UNITED STATES PATENT AND TRADEMARK OFFICE

10/588,625

Chojiro Kuriyama

Office Action Summary	Application No. 10/588,625	Applicant(s) KURIYAMA, CHOJIRO	
	Examiner DAVID M. SINCLAIR	Art Unit 2831

Figure 1: Altered version of Arai '534 fig. 6C showing examiner labels

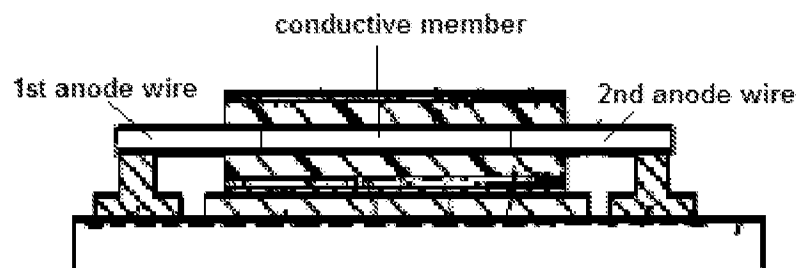
A solid electrolytic capacitor comprising a porous sintered body of valve metal (6 – fig. 6; [0050]); a first and a second anode wires partially extending into the porous sintered body (present office action fig. 1 (POA1); [0050]), portions of the first and the second anode wires which project out from the porous sintered body serving as a first and a second anode terminals; and a cathode including a solid electrolytic layer formed on a surface of the porous sintered body ([0050]);

The solid electrolytic capacitor according to claim 1, further comprising a conductive member for electrically connecting the first and the second anode terminals to each other (POA1).
